Overall Design

Boulware Park Schematic Design Option 2

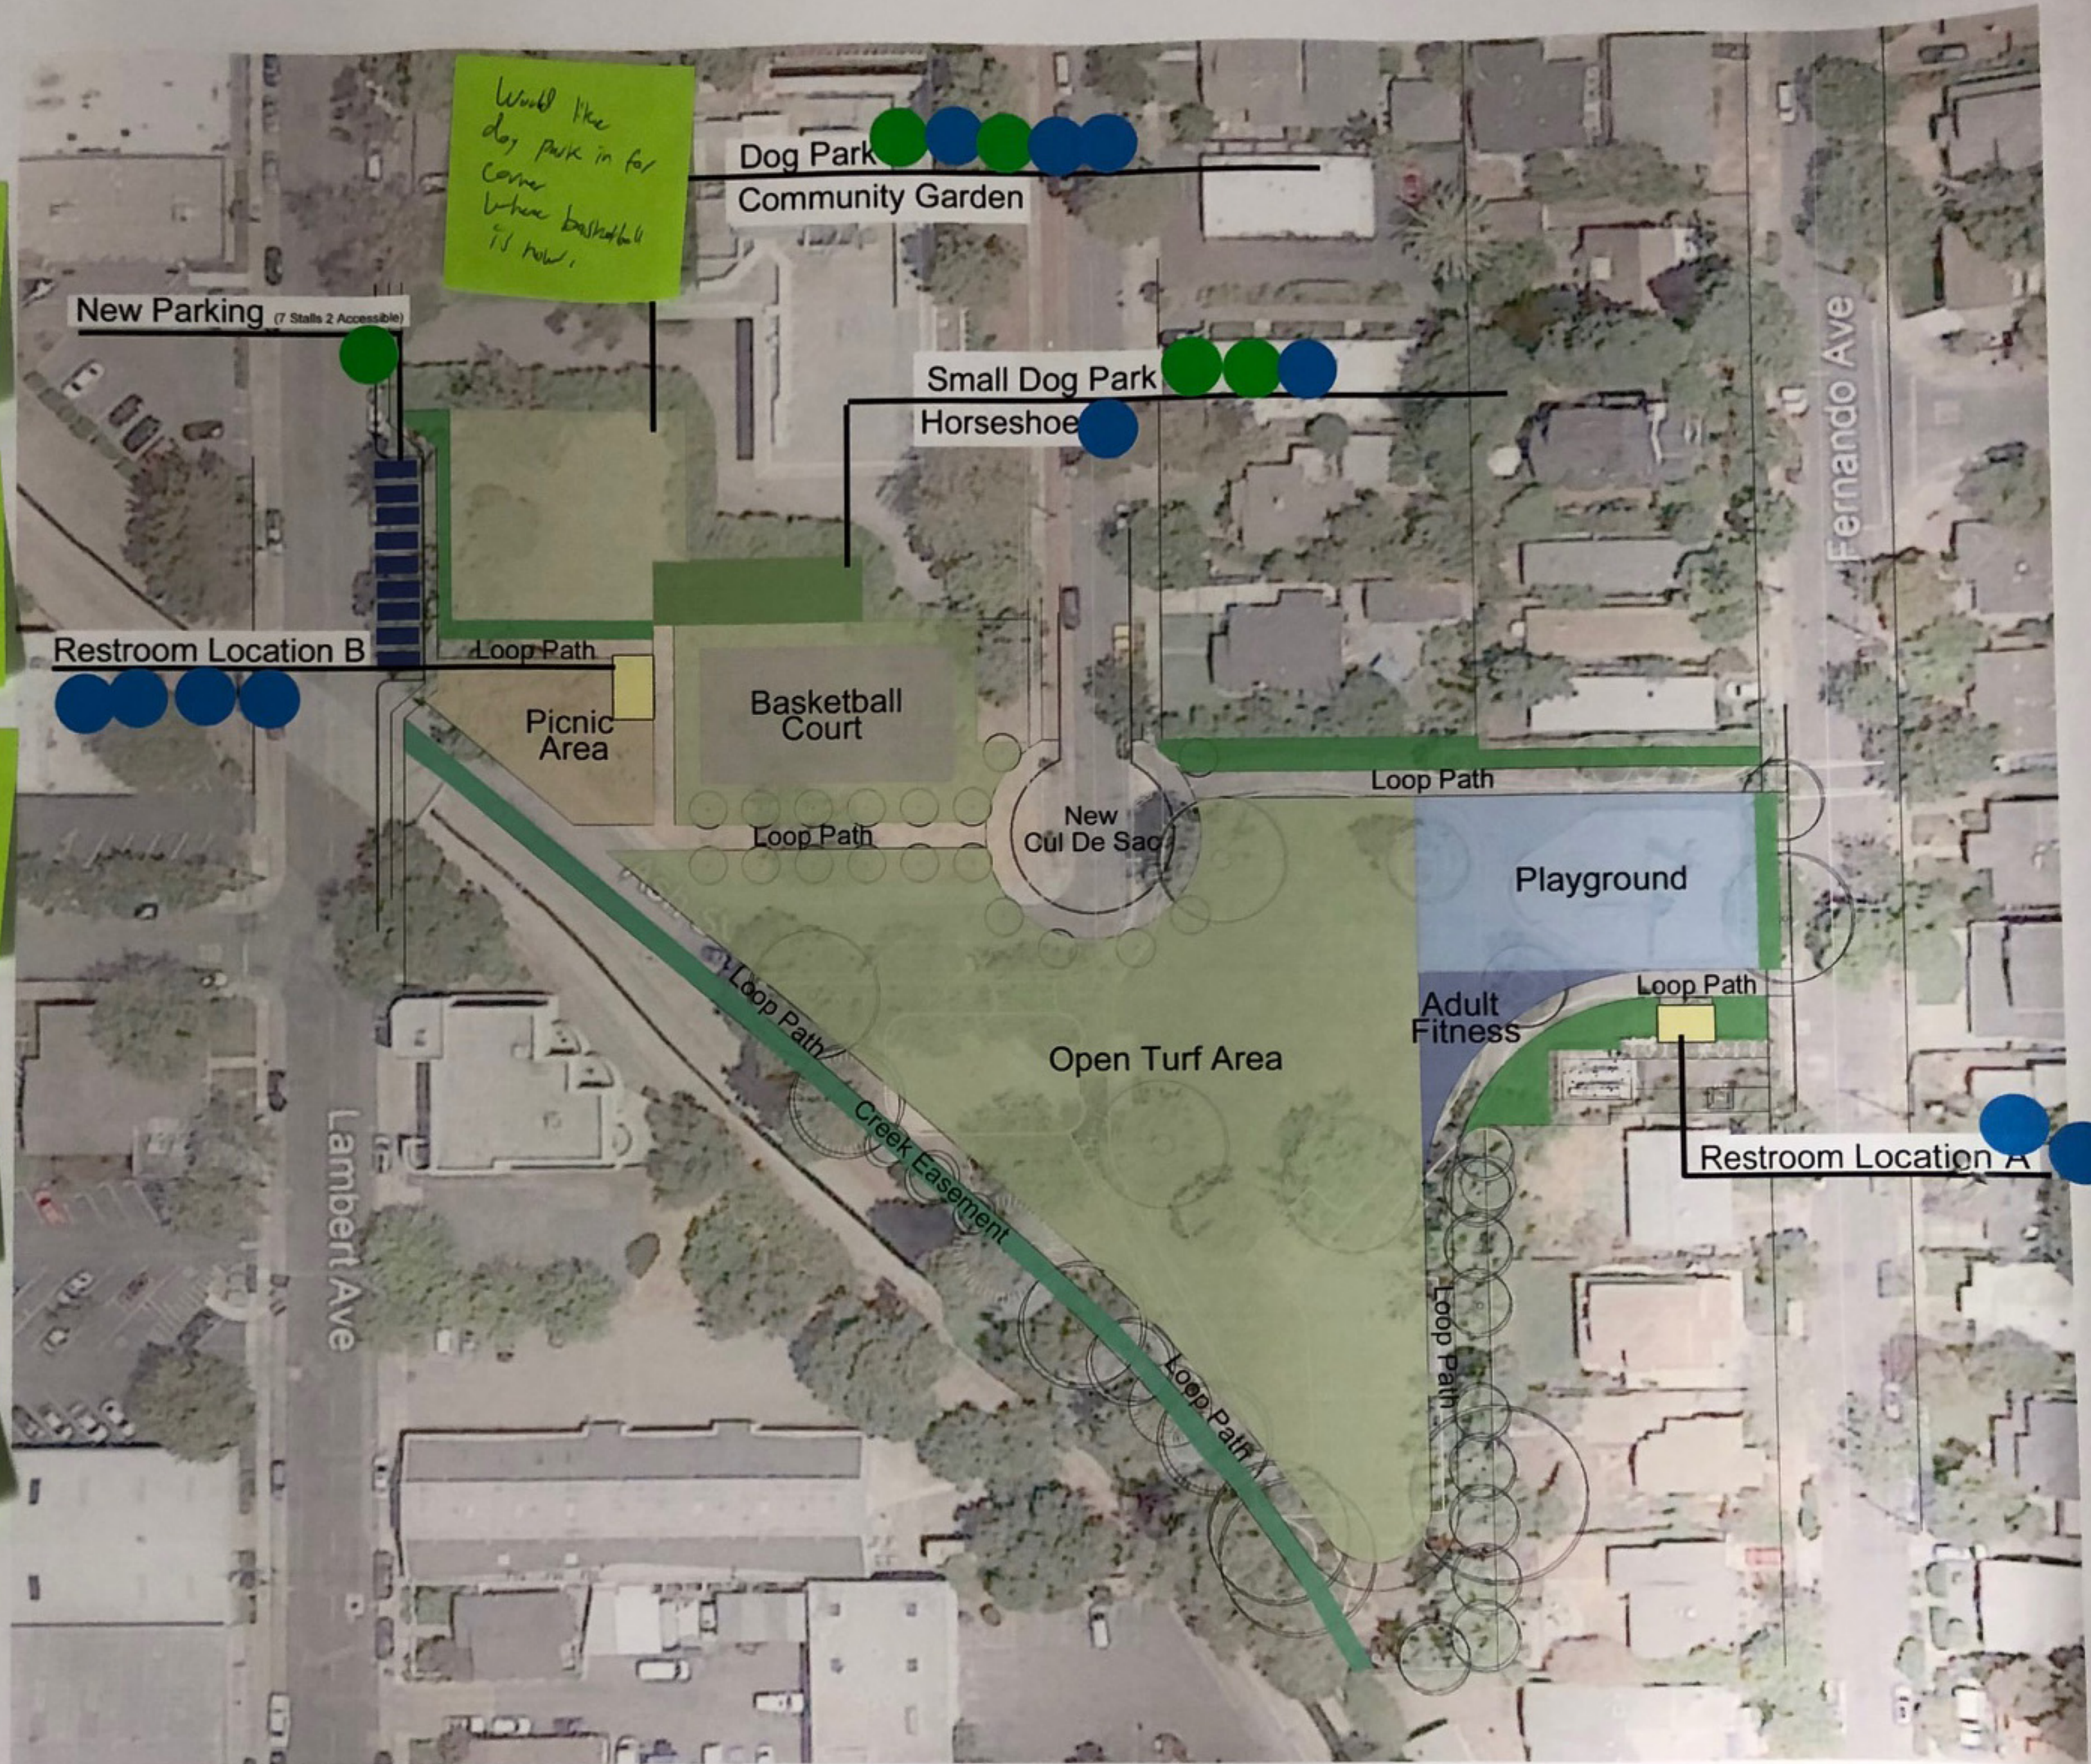
No need for parking other than existing lot

No off-street parking! Pavings for people not cars!

Design has best elements plus some small parking which along Lambert

Community garden plot would benefit from max solar exposure

Native plantings are important to me and should be everywhere ~~the~~ non-lawn plantings go in.

Landscap- only use natives.

P.A. has no park - it is old, and was by popular 'ity' even if it ended up getting few fewer votes.

Why so much space given to a dog park when it was a low priority on the survey?

Need picnic area near playground w/ shade

Would like dog park in far corner where basketball is now.

Boulware Park Schematic Design Option 2

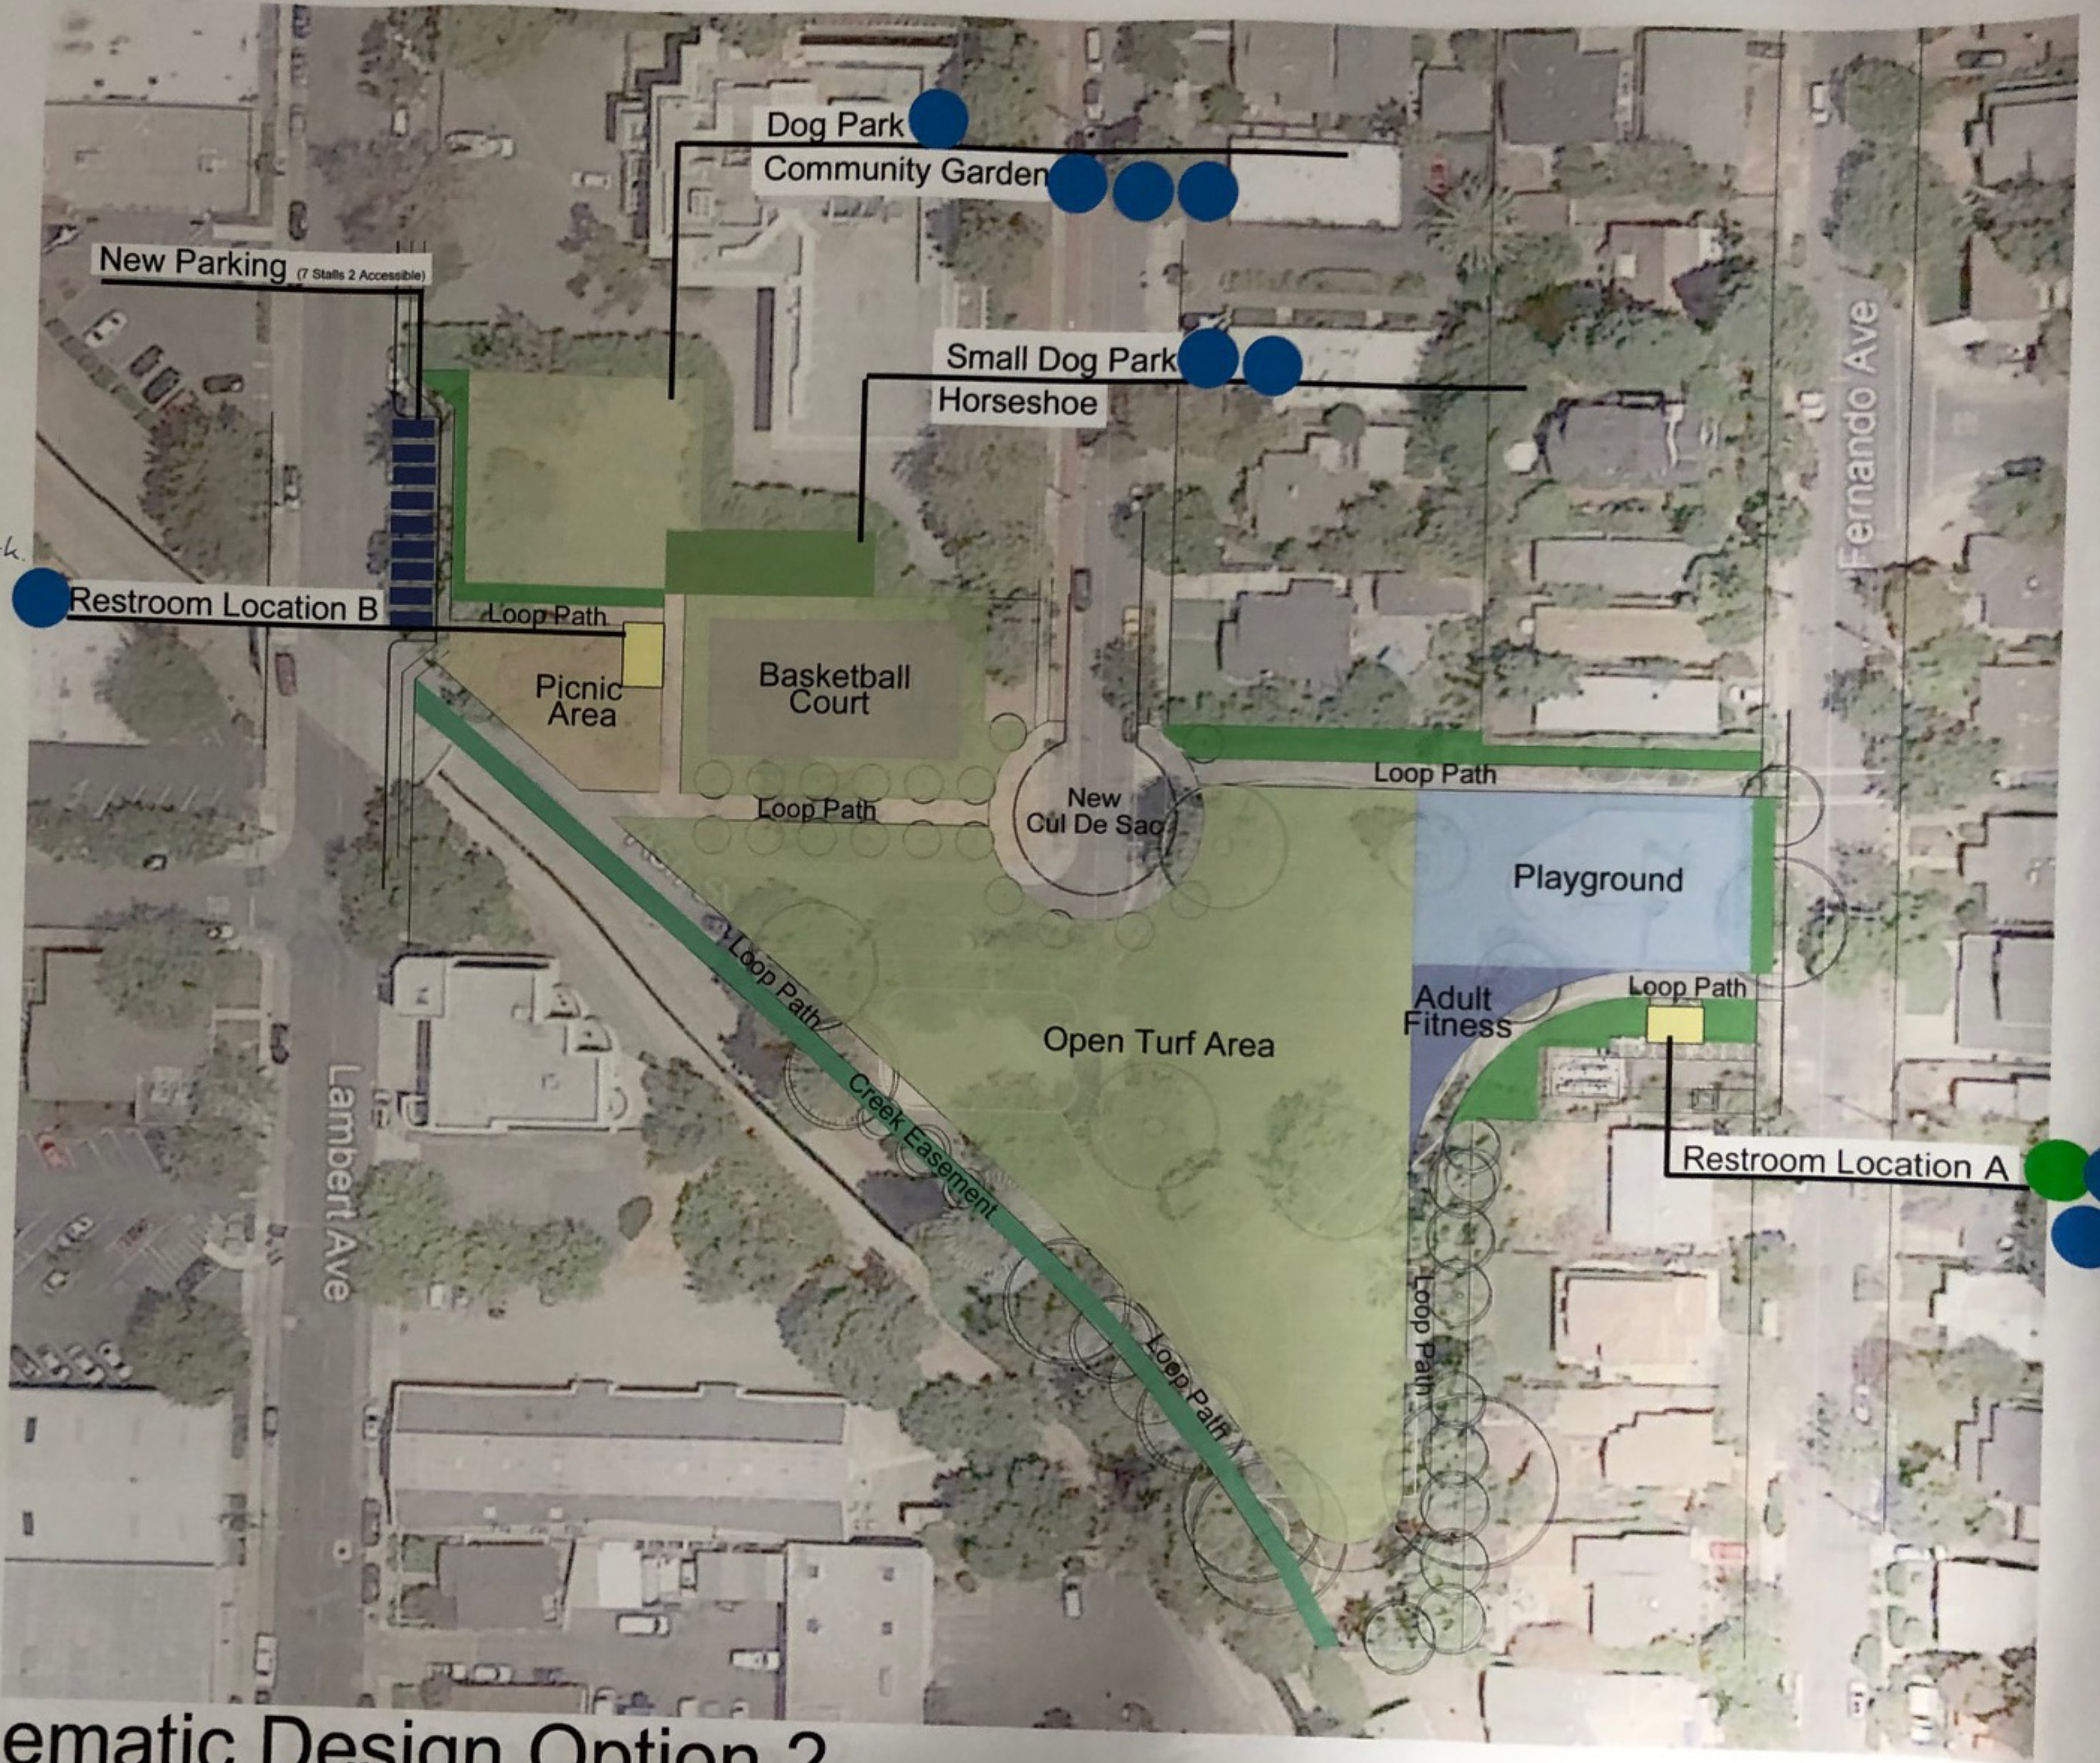
1) Enlarge picnic area

There is sufficient parking without these new stalls - Lambert, Chestnut

2 restrooms - one by playground, one by picnic
Closer to Fry's site is good.

picnic area further from road & traffic
like near triangle of loop path, creek & culdesac.
park slope into creek, make creek play part of park.

DON'T BUILD BUILDINGS ON THE PARK. STAY WITHIN STRICT COST
LIMITS. FINANCING CAN BE INSECURE.

Restroom always near playground.
